# E4418A-06C

# S E R V I C E N O T E

## E4418A EPM Series Power Meter

### Hardware Upgrade Information

**Figure 2: DSP Revision Check**

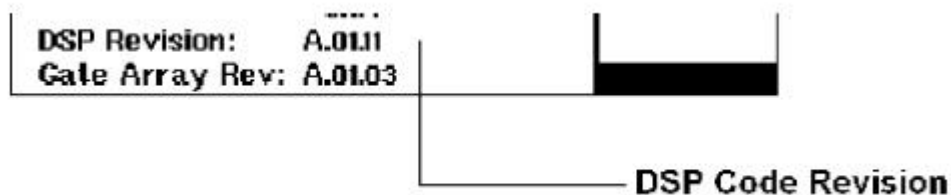
1. Reconnect the power cord and switch the power meter on.
2. On the power meter, press **System/Inputs > More > Service > Self Test > Instrument Self Test**.
3. Verify all tests pass.
4. If any Measurement Assy tests fail, switch off the power meter and proceed as follow:
  - a. Remove the power cord and remove the cover as described in "Cover Replacement".
  - b. Ensure the EEPROM, flex circuit and measurement assemblies are correctly located.
  - c. Refit the cover and retest the power meter.
5. Press **Done** to exit the Instrument Self Test menu.
6. Verify the DSP Revision after the Instrument Self Test has passed. Press **System/Inputs > More > Service > Version** to check the DSP Revision of A.01.11 as shown below:
